re: RUTHERFORD - WESTBROOK PLACE - YOUR
REF: 6596021

Re: Petrie St Flooding Problem

Re: Westbrook Place Secondary Flowpath

RESOURCE MANAGEMENT ACT 1991
NON-NOTIFIED APPLICATION FOR SUBDIVISION CONSENT
DJ RUTHERFORD, WESTBROOK PLACE

Typical x-s for
new secondary flowpath
at Westbrook Place

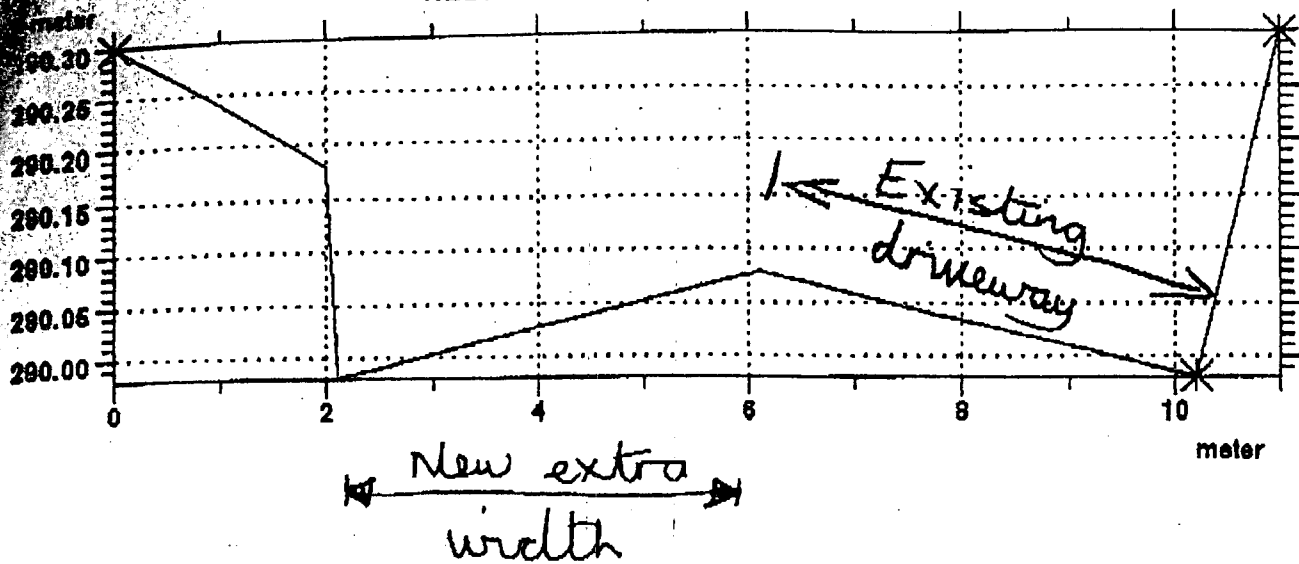
As requested I tested the model for a secondary flowpath in Westbrook Place. The assumptions I made were;

1. The combined width of the secondary flowpath is 8m (2 driveway widths, cross section plot is attached).
2. The new 1200mm pipe is included
3. The highest ground level at the beginning of the driveways (ch. 10.110km) is RL290.30m
4. The ground level at the back house (ch.10.189km) is RL289.84m.
5. Stormwater can flow freely into the back paddock without ponding above RL289.70m.

The water level at 22 Petrie St dropped a further 80mm due to the new pipe.

The flow through the secondary flowpath at Westbrook Place peaked at 700l/s.

The pipe flow under Westbrook Place peaked at 3,500l/s.

The water depth for the new secondary flowpath was 100mm.

The water level peak along the secondary flowpath was RL290.40m.
